PIC18F6620/8620/6720/8720

PIC18F6620/8620/6720/8720 Rev. A3 Silicon/Data Sheet Errata

The PIC18F6620/8620/6720/8720 parts you have received conform functionally to the Device Data Sheet (DS39609B), except for the anomalies described below.

FIGURE 26-3: PIC18F6620/6720/8620/8720 VOLTAGE-FREQUENCY GRAPH (INDUSTRIAL, EXTENDED)

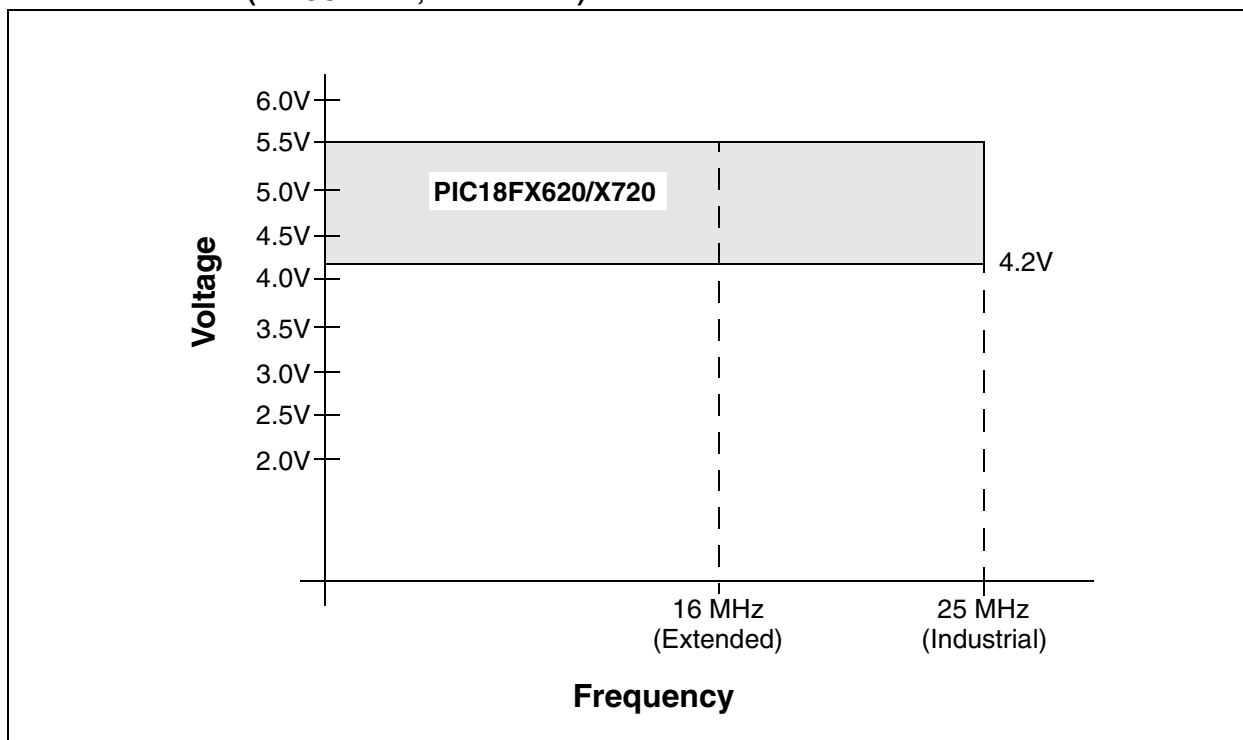
1. Module: Voltage-Frequency Graph

In Section 26.0 “Electrical Characteristics”, the following figure has been updated to clarify the voltage frequency for extended devices.

FIGURE 11-1: TIMER0 BLOCK DIAGRAM IN 8-BIT MODE

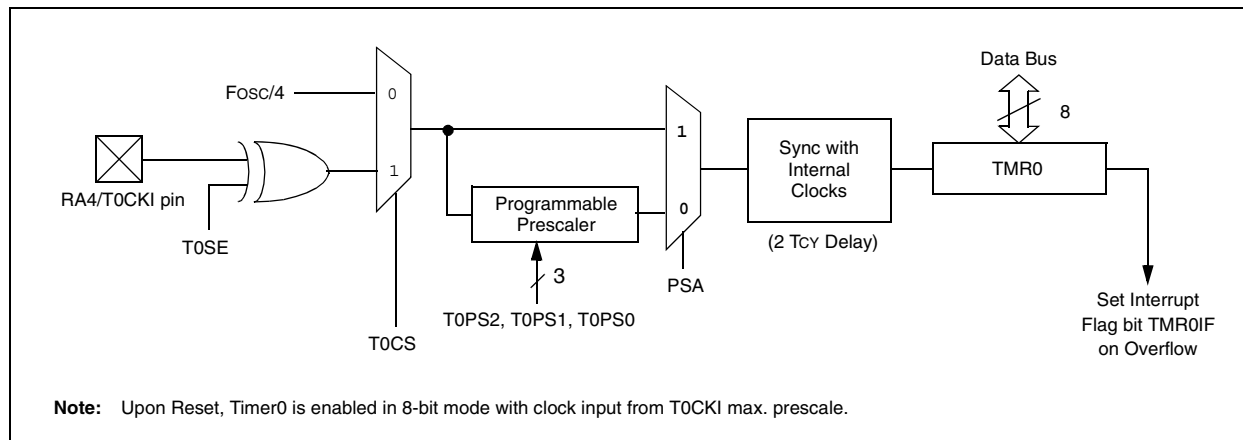
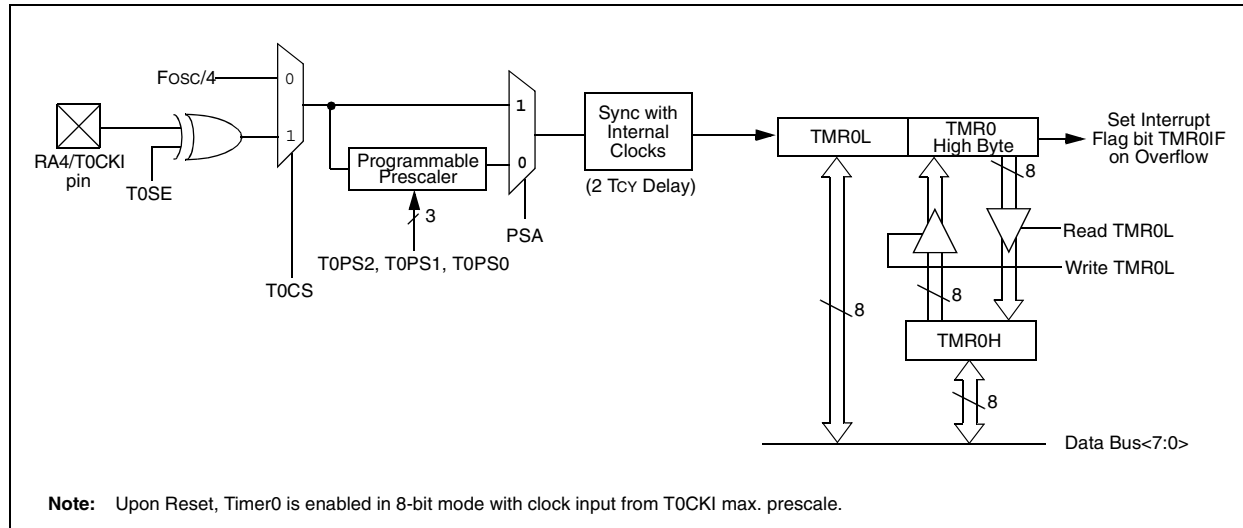
10. Module: Timer0 Block Diagram in 8-Bit and 16-Bit Modes

The PSA multiplexor bit values in Figures 11-1 and 11-2 do not match the text description of the Timer0 PSA bit in the T0CON register.

The bit values have been corrected by swapping the values as shown below (correct values are shown in **bold text**):
